Detailed Site Plan

DSP-18017

| Application | General Data | |
|--|------------------------------|-----------------|
| Project Name: JDA Baltimore Avenue Location: West of the intersection of US 1 (Baltimore Avenue) and Hollywood Road. Applicant/Address: JSF Management, LLC 100 Dunbar Street, Suite 400 Spartanburg, SC 29306 | Planning Board Hearing Date: | 07/26/18 |

SUBJECT: Detailed Site Plan DSP-18017
JDA Baltimore Avenue

ARCHITECTURAL ELEVATIONS

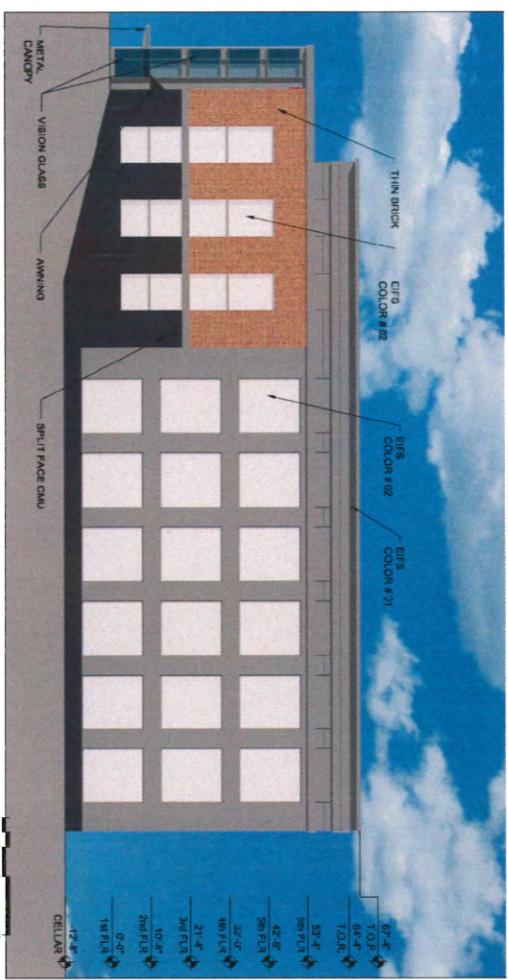
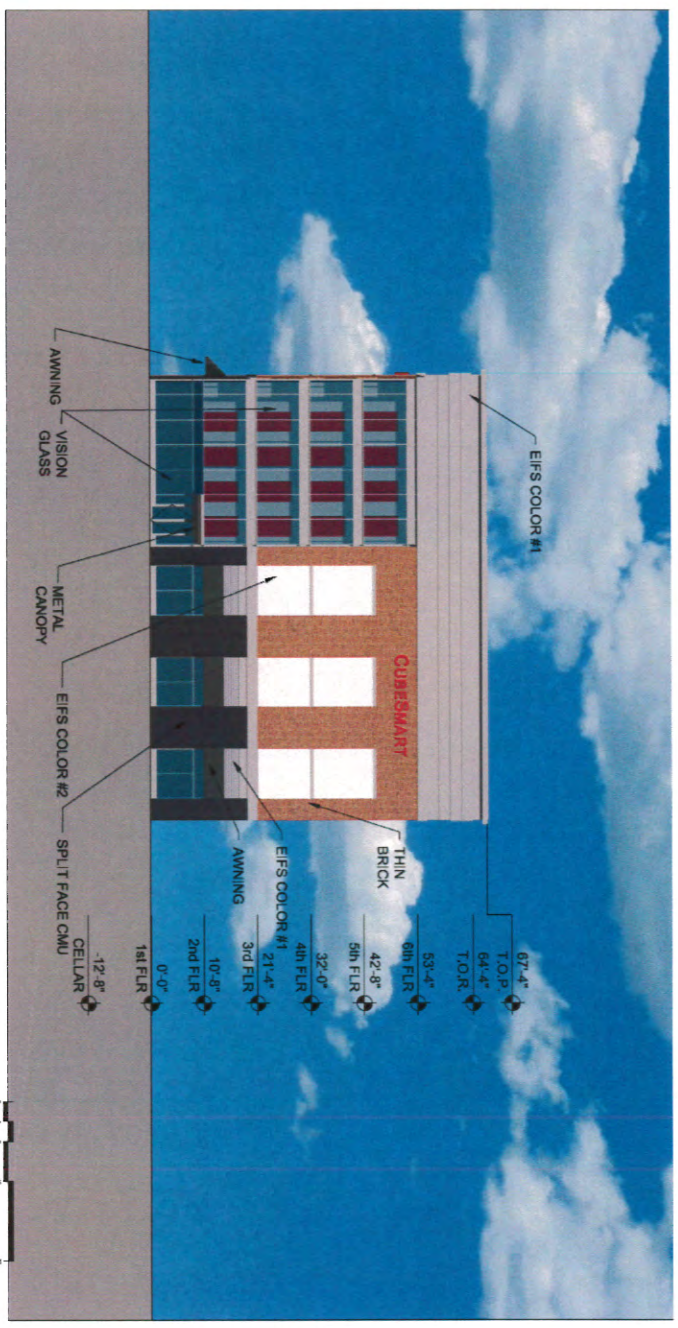
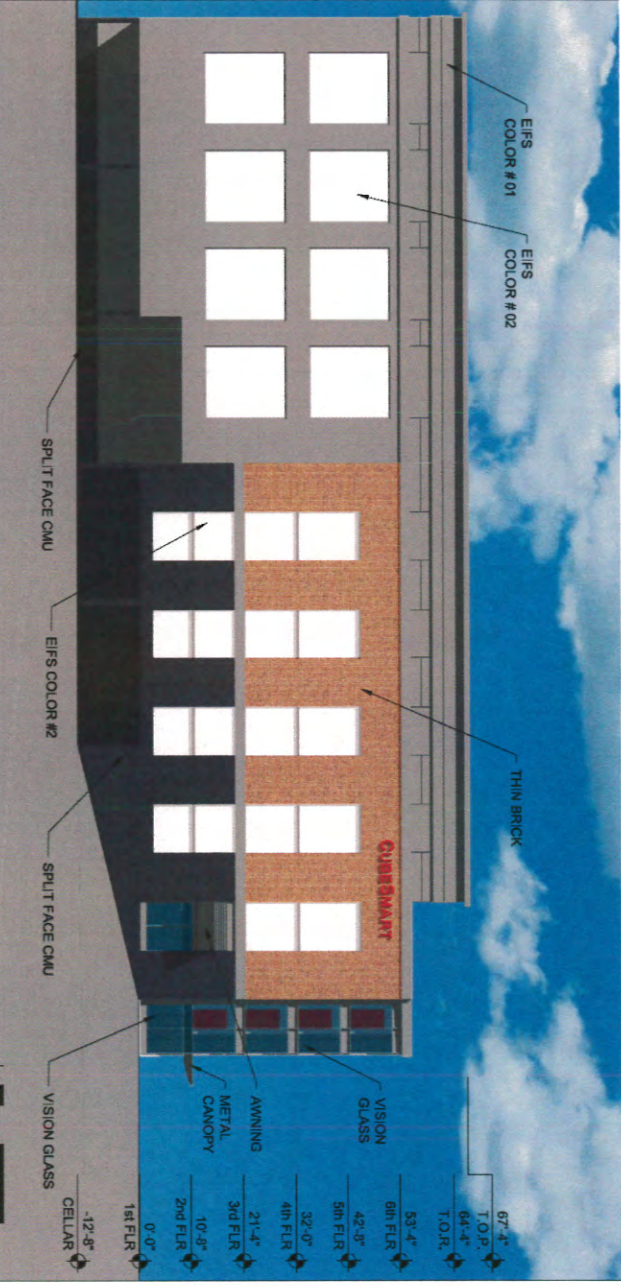
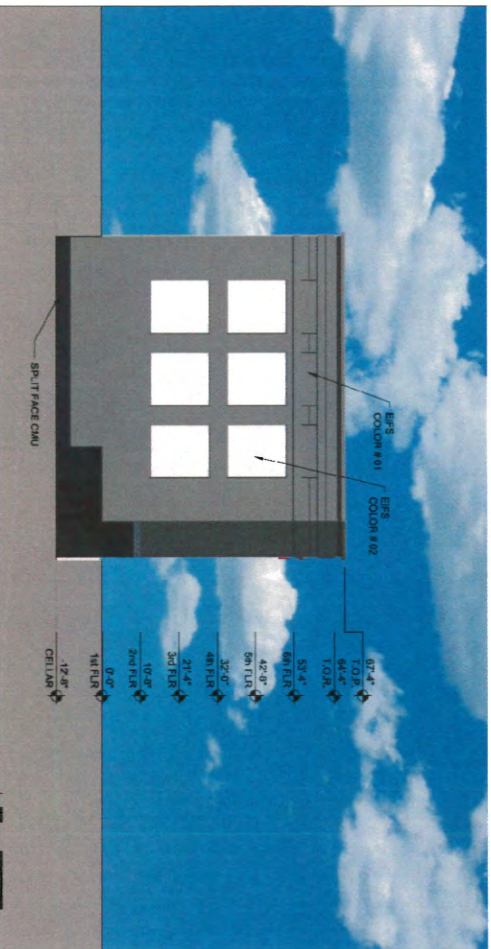
The architectural elevations show a flat roof building with the front section along US 1 as five stories, and rises to six stories, with a setback of approximately 20 feet from the front. Substantial effort and commitment has been expended in order to provide an architectural style which appears as an office building, when viewed from the US 1 frontage. The first floor of the building contains substantial glazing to provide windows and doors for the office area. Awnings are proposed for portions of the eastern and southern elevations to enhance architectural interest. A

BUILDING SIGNAGE

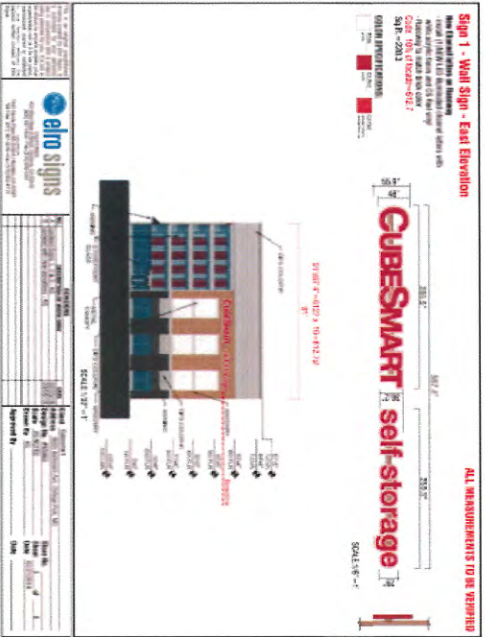
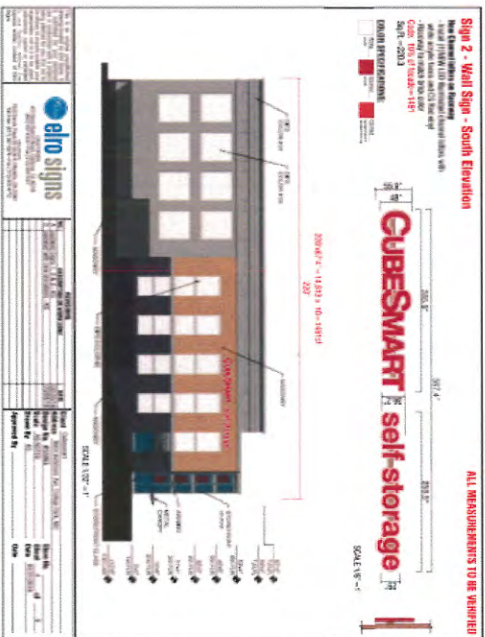
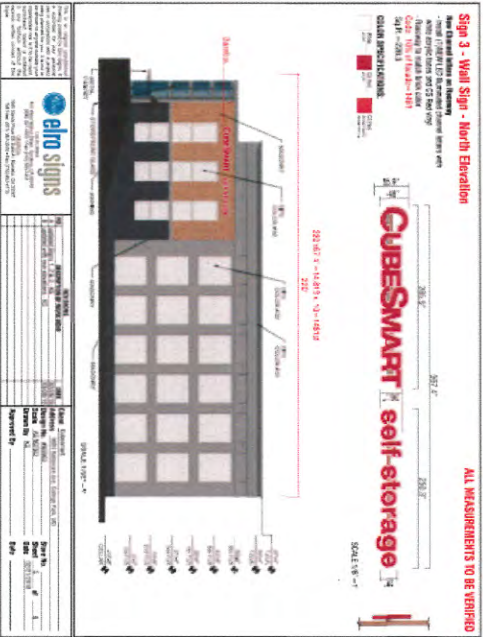
Signage—A signage plan has been filed with this application. A total of four signs are proposed. Two signs are proposed to be located on the front (or eastern) elevation of the building. A single sign is proposed to be located on both the northern and southern elevations of the building, close to the front of the building. These signs are proposed in order to advise patrons as to the location of the building. The building carries a primary identification sign of “CubeSmart,” a national consolidated storage operator. CubeSmart will operate the business on the property on behalf of the developer, Johnson Co. Three building signs will be located beneath the cornice area on the eastern, southern, and northern elevations of the building. These signs are to read “CubeSmart self-storage.” It is proposed that the lettering of the signs will be red, in order to be complimentary with the red brick treatment on the building. The fourth sign will indicate “office” and will be more directional in nature, in order to guide patrons to the entrance of the office area. This fourth sign will be located immediately above the entry door to the office on the eastern elevation.

In addition to the building signs, certain directional signs will be located on-site. A detail sheet for these directional signs is included as part of the site plan package. The D-D-O Zone signage standards on sign area allow up to 10 percent of the façade area in signage where the building sign is located. The largest sign is around 220 square feet, which is well below the maximum sign area allowed by the D-D-O Zone standards.
